REQUEST FOR INFORMATION **DATE:** March 15, 2017 **NO.:** RFI-486

Project Name: 15051-Webster University Interdisciplinary Science Building Project No.: 15051

Subject: Curtainwall fin Splice locations

A0312

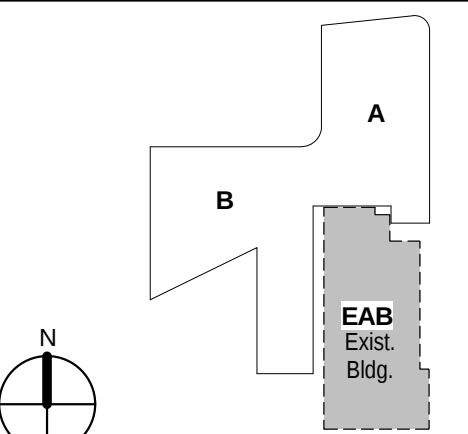
Please advise of where the splice locations for the fins are to be located in the tall curtainwall areas on the North, South and partial West elevation (there will be 2 splices in these areas). The splices can be minimized to approx. 1/4". We would suggest locating these adjacent to another horizontal element/floor line/etc.

PROVIDE FIN SPLICE LOCATION PER MARKUPS.

OPTION-1 (GREEN MARKUPS): FIN SPLICE LOCATION IF SPLICE IS NOT NEEDED AT WEST CANTILEVER.

OPTION-2 (MAGENTA MARKUPS): FIN SPLICE LOCATION IF SPLICE IS NEEDED AT WEST CANTILEVER.

IF POSSIBLE, PREFER NOT TO HAVE FIN SPLICE AT WEST CANTILEVERED PORTION.

FIN SPLICE LOCATION IF SPLICE IS NOT
NEEDED AT WEST CANTILEVER.

FIN SPLICE ONLY IF REQUIRED.
PREFER TO NOT HAVE FIN SPLICE
IN THIS AREA

FIN SPLICE LOCATION IF SPLICE IS NOT
NEEDED AT WEST CANTILEVER.

FIN SPLICE ONLY IF REQUIRED.
PREFER TO NOT HAVE FIN SPLICE
IN THIS AREA
